# Recall Notice Service Bulletin 514501 Rev. A

NHTSA Recall #: 21V817  
Transport Canada Recall #: 2021-636

Applicable for Chevrolet Traverse Power Infloor  
Conversions manufactured November 9, 2020 to  
September 10, 2021

# Chevy Traverse Screw Removal and Transmission Case Inspection 514501 Rev. A

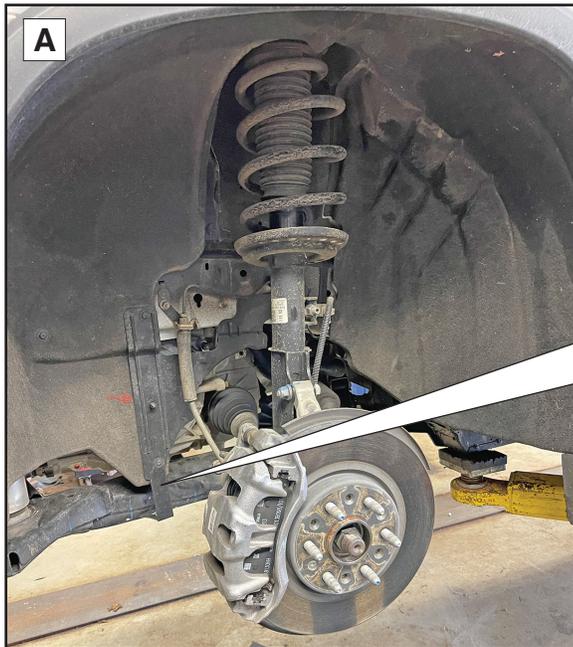
Summary: To prevent wear to transmission case,  
remove screw and screw clip and replace with nylon  
push rivet.

Materials Required:  
3/8" Nylon ribbed push rivet  
(not to exceed 1" in length)

Screw  
L-Bracket

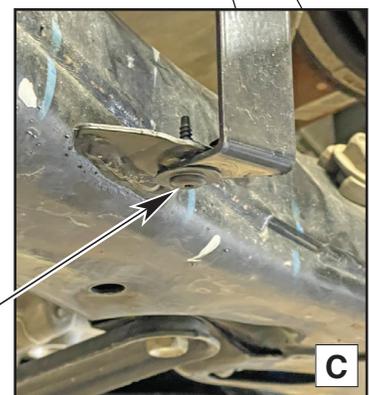
2. Remove wheel well liner L-bracket. See  
Photos A through C.

Wheel Well Liner Support Bracket

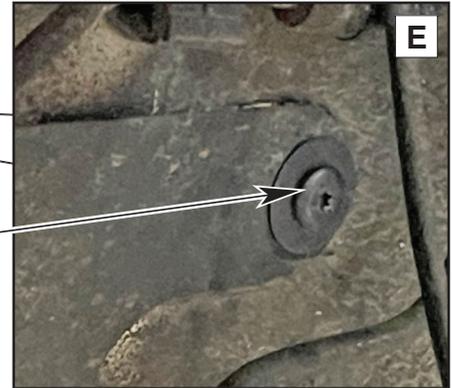
3. Remove wheel well liner support bracket.  
See Photos D and E.

Screw  
Clip

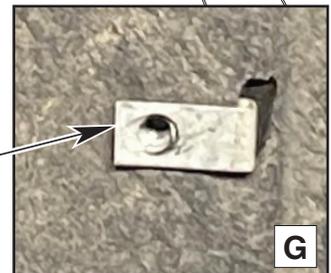
4. Remove and discard screw clip shown in  
Photos F and G.

6. Reinstall wheel well liner support bracket. Place a 3/8" diameter ribbed push rivet (no longer than 1" in length) at center screw location. Insert from the inside facing out as shown in Photos J and K.
